Our Ref FR111017-004/Letter 003
Contact Daniel Thompson

Date 7 November 2014

RE: KEMBLA GRANGE RESOURCE RECOVERY FACILITY

Figure 2 Section from EIS Figure 16, with PAC's sites and identified Sensitive Receivers.

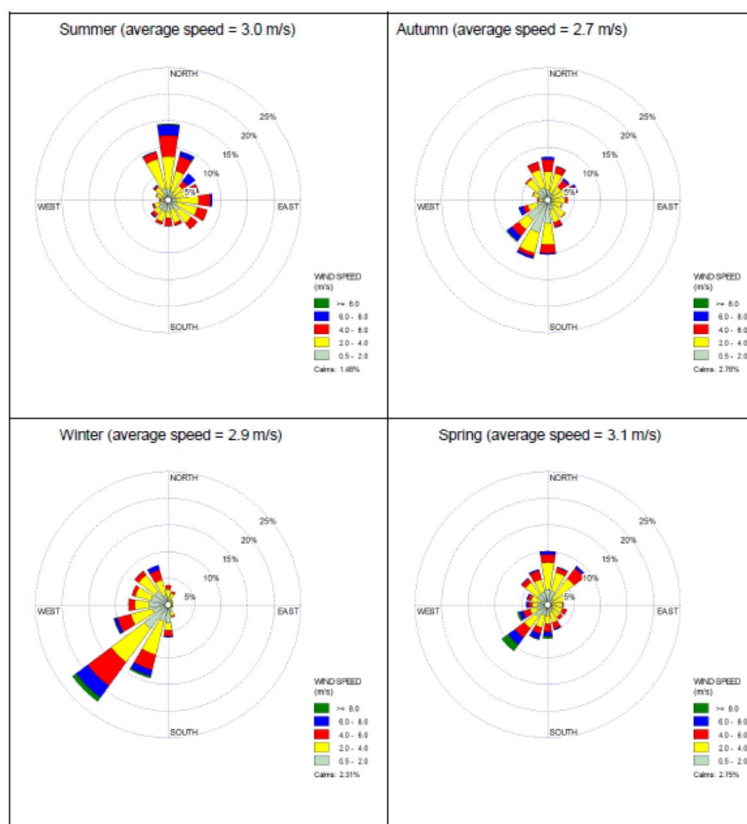
Those sensitive receivers identified in Table 1 of the Air Quality Assessment are all located north or east of the proposed development. No modelling has been conducted for receivers to the south or west of the proposed development which are currently used by PAC and other organisations for employment purposes.

Figure 5 Predicted – Cumulative PM₁₀ 24-hour Average Concentration (with mitigation) µg/m³

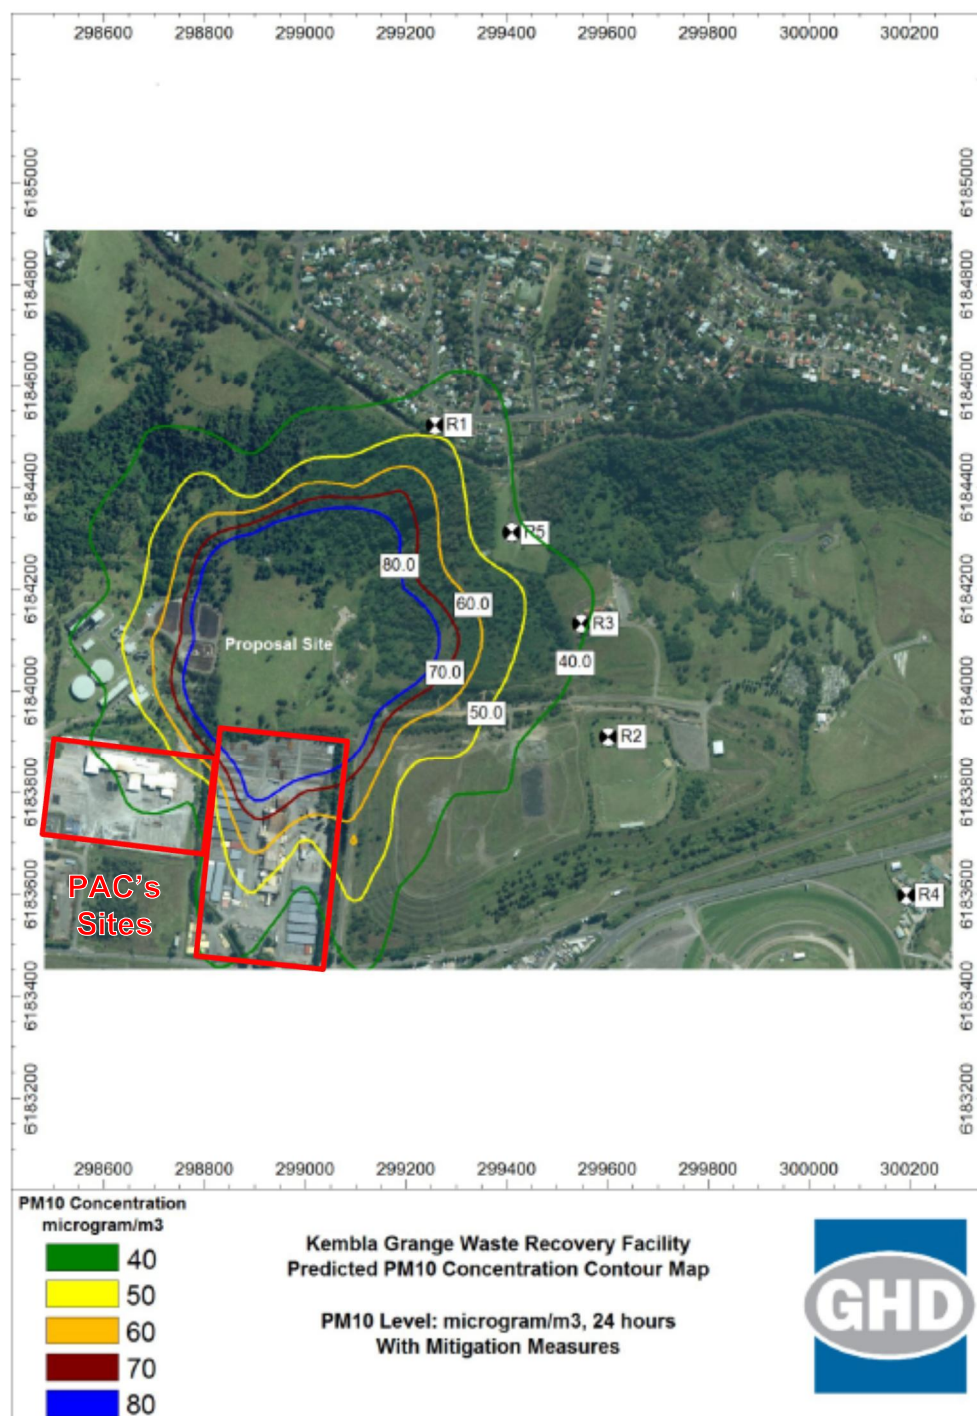
The Air Quality Assessment shows the results of the air quality predictions with mitigation measures in Figure 15. The assessment predicts that even with all mitigation measures in place, the PAC site at 66 West Dapto Road will be exposed to a maximum 24 hour average of 50 to 80 micrograms per cubic metre of PM₁₀ particles (See figure 5). Approximately half the site area would be exposed to PM₁₀ concentrations of 50 micrograms per cubic metre or more. The impact at 17 Reddalls Road would be less with levels between 40 and 70 micrograms per cubic metre.

The Air Quality Assessment notes in Table 13 that the regulatory criteria for exposure to PM10 particles over 24 hours is 50 micrograms per cubic metre. This level is exceeded significantly at PAC's 66 West Dapto Road site.

Figure 6 Predicted Peak Odour Contour Map, OU with building ventilation and biofilter

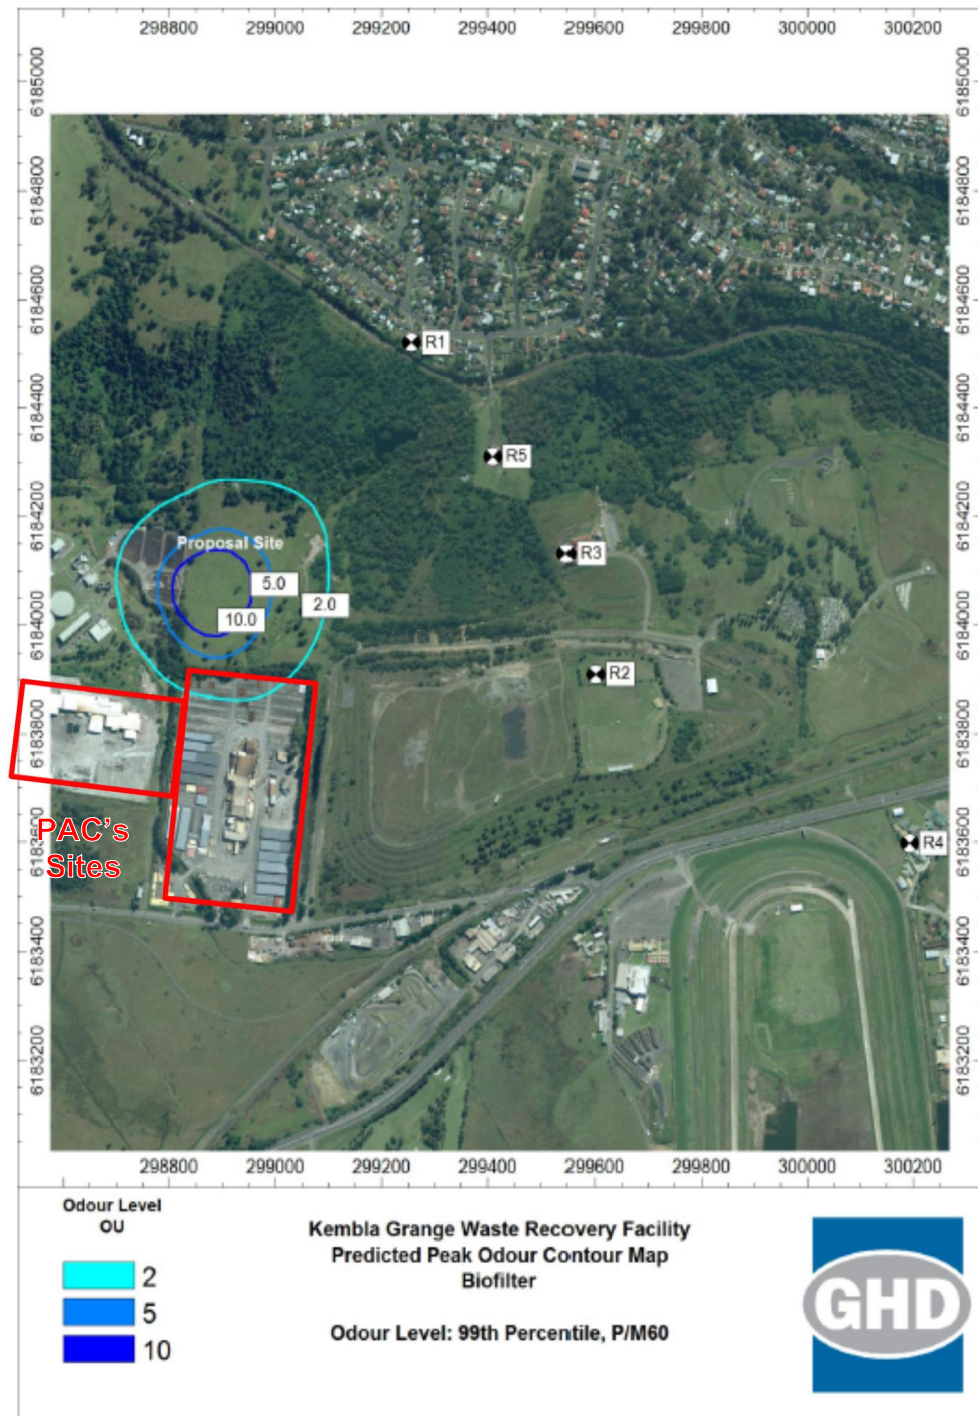
The KGRRF facility would emit unpleasant odours to an even greater extent than currently occurs due to the expanded operations. Even with all proposed mitigation measures there would still be an unacceptable odour at the northern end of PAC's site at 66 West Dapto Road (See figure 6). This odour could over time permeate the cars stored on this section of the site, with PAC required to introduce an enhanced cleaning regime to maintain these vehicles in an acceptable condition. Furthermore, odour would have an impact on the amenity of the surrounds for staff.
